## **STAFF REPORT**

**To:** RVCA Executive Committee – Application Hearing  
**From:** Eric Lalande, MCIP, RPP, Senior Planner, Planning and Watershed Science  
**Subject:** Hearing of Application for Development – Ontario Regulation 174/06  
**Date:** February 8, 2024

**Application:** RV6-0622 and RV6-4723 (Violation)

### **Revised Application for Development:**

1 BASEMENT SECTION  
D12 SCALE: 3/16"=1'-0"

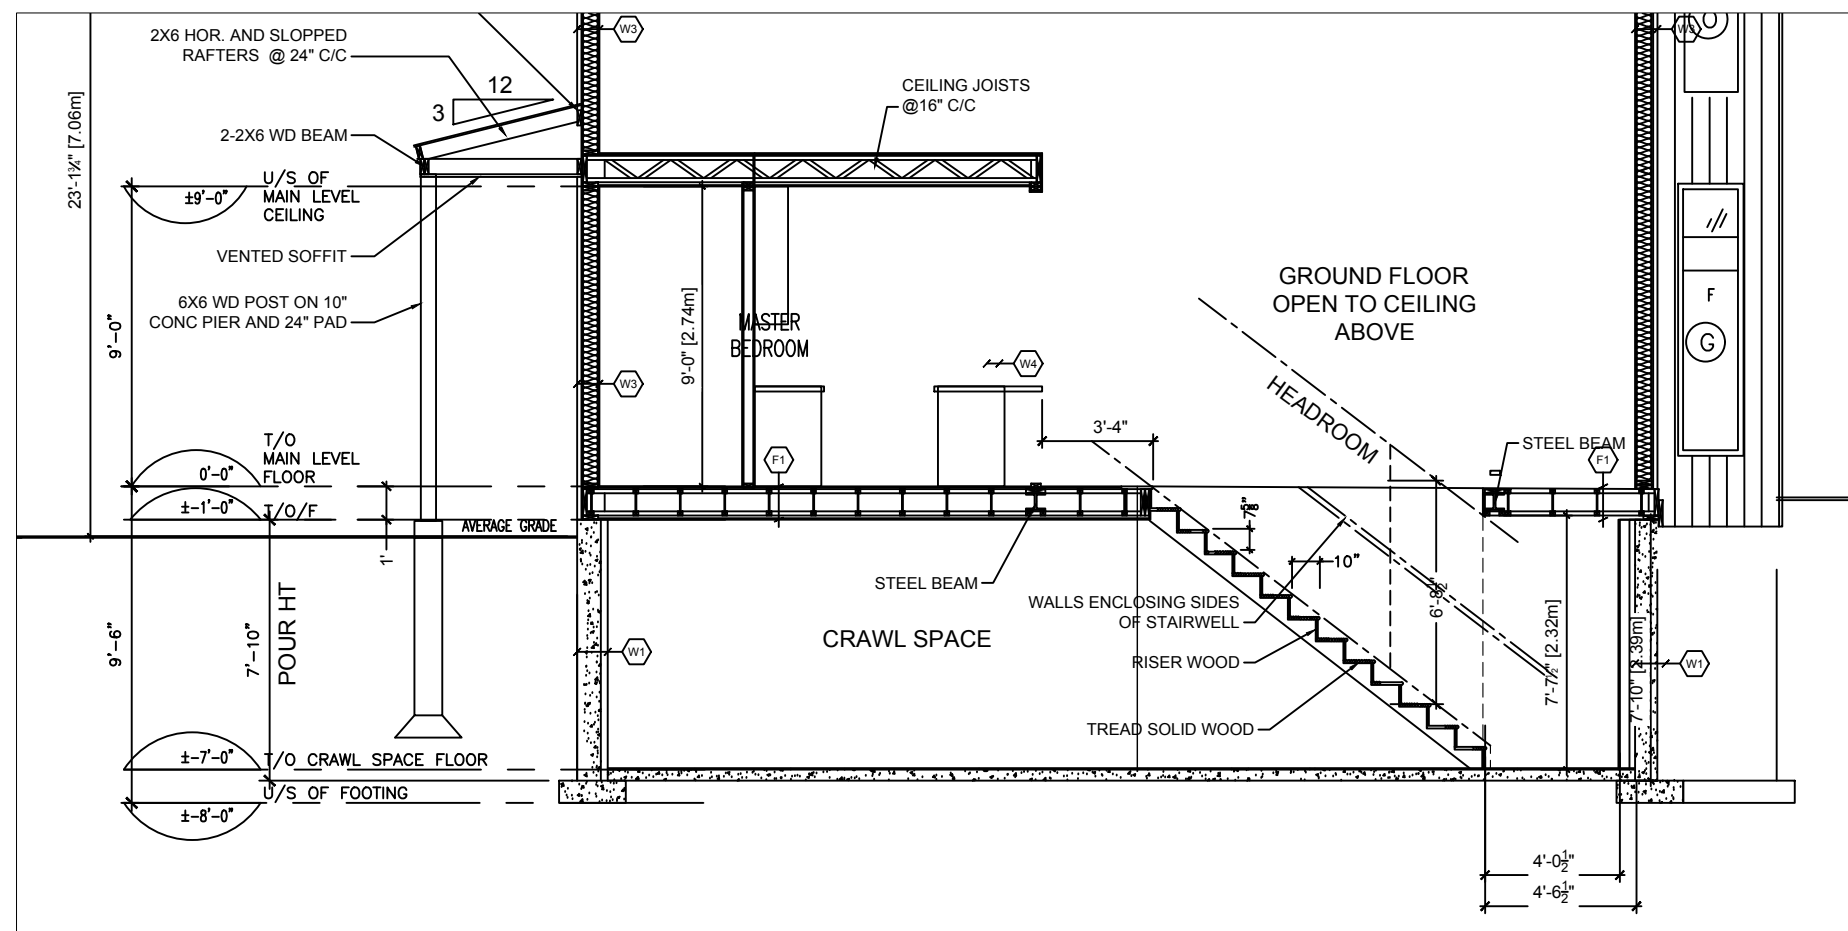
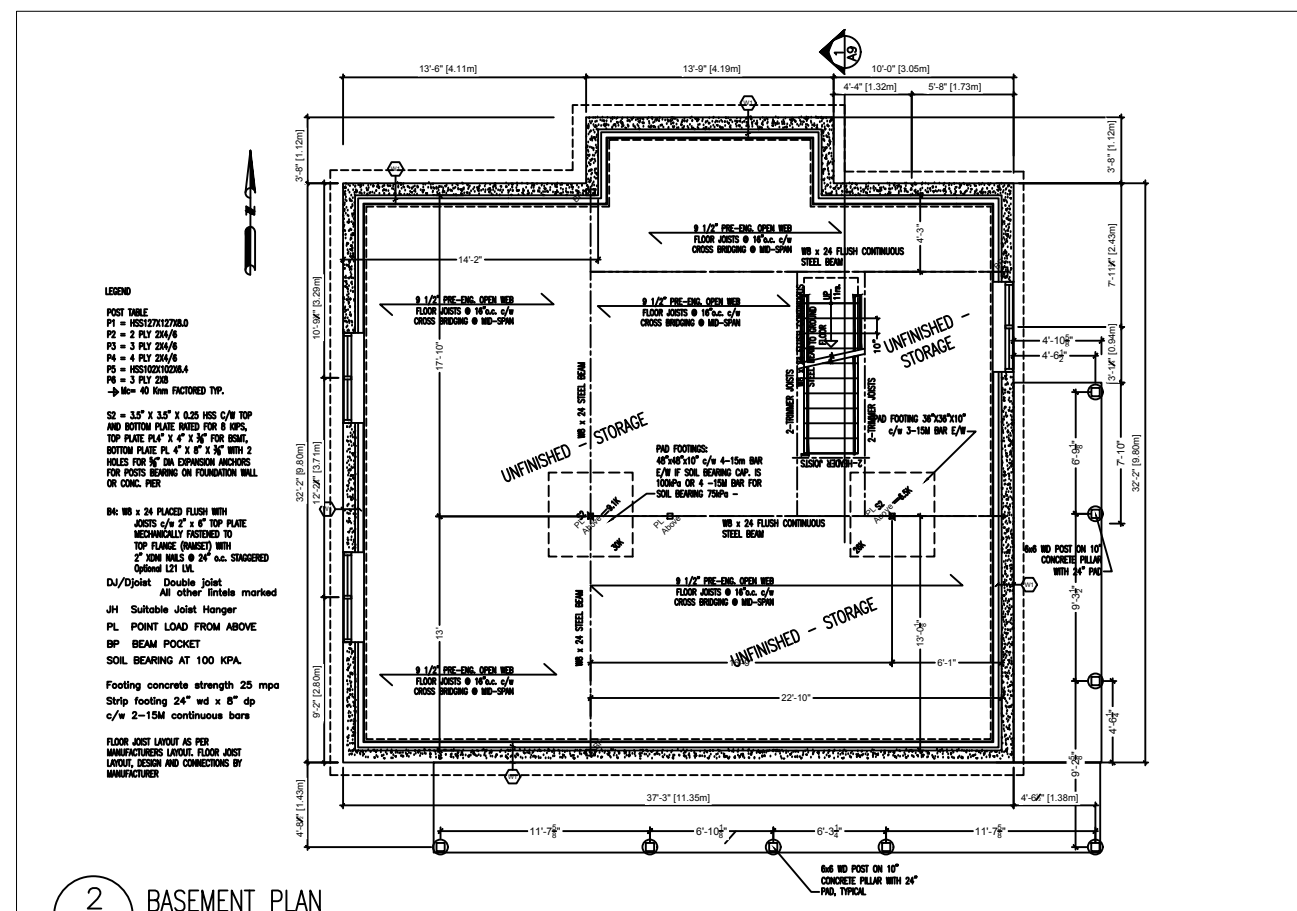
The structure has provided limited details for the foundation and require certification from a Professional Engineer to allow for a full basement. This is a requirement to comply with policy for a full height basement and is a distinct change in requirements over a wet floodproofed crawlspace that was originally approved. The RVCA acknowledges that professional engineered drawings have not been provided given the gross floor area concerns and was not made a requirement of the complete application. The supporting documentation provides limited components to improve the foundation, however, insufficient information is available for staff approval. Elements such as the electrical systems appear to be located below the regulated flood elevation. Elevations of window openings, or commentary on foundation walls withstanding hydrostatic pressures are not included in the design drawings. Sump pump details or elevation data on mechanical and electrical facilities are not available in the submitted drawings. Additional, Wet Floodproofing of a full height basement is prohibited.

There is insufficient information for RVCA staff to comment on floodproofing measures proposed by revised design.

3. The additional living space is not consistent with applicable floodproofing measures as it is located below the regulated flood elevation and a floodproofing design prepared by a qualified professional has not been submitted as part of the application.

It has been brought to attention that the approved plans limit the lower level height to 5'11" as a result of the committee of adjustment decision file no. D08-02-21/A-00439. Current construction of the lower level appears to not be in conformance with the aforementioned.

- 5) **The approved plans limit the lower level height to 5"-11" as a result of the committee of adjustment decision file no. D08-02-21/A-00439. Current construction of the lower level appears to not be in conformance with the aforementioned.** The height limitation on this space is explained by RVCA as intentional to limit the area as an unused crawl space to allow possible flood waters to pass through in and out of the crawl space through the foundation windows. We were told that because of this, all mechanical would need to be suspended under the floor above to prevent flood damage to it.

This arrangement would promote a very unhealthy environment with mould, dampness and likely cause serious health issues for myself and my wife. The overall lower level height was determined by the size of available concrete forms used in constructing the foundation walls of our home. We are both in our late sixties and live alone so we cannot understand the perceived threat we have made by constructing our retirement home with a lower level that we can utilize as storage space for our belongings rather than living with a damp area right under our feet. I am also six feet tall and the height limitation will impact my ability to maintain good posture and result in neck pain and lower back pain. Additionally, to maintain our health as we are aging, we have several pieces of exercise equipment we use. These equipments will not be able to be accommodated within a crawl space. The limits also placed on the size of the footprint of our house prohibit the use of this equipment on the main floor level.

The lower level height was extended for reasons stated above as well as to accommodate trades accessing the space to work safely and efficiently. It will not be used as habitable space. Additionally, we discovered that installing HVAC/plumbing mechanical suspended under floor is impractical and significantly more expensive. As such, all HVAC systems are mounted on the foundation slab. Radiant floor heating system is also situated within the foundation slab. Electrical outlets are present and spaced every 12' as per building code requirements.

The lower level space is fully waterproofed, insulated and has a double sump pump system in case water ever did get in. The HVAC system includes a HEPA air filtration system and the height of the lower level window openings are actually situated higher than the critical level of possible flooding as reported for the 1:100 year flood plain. The footprint of our home is also so very small, neighbouring properties cannot possibly be affected by any water that might be displaced if it ever reached our foundation. We want to be able to keep water out, not let it in.

As such, we seek RVCA approval to retain the current configuration of the lower level. See attached photos and inspection report.
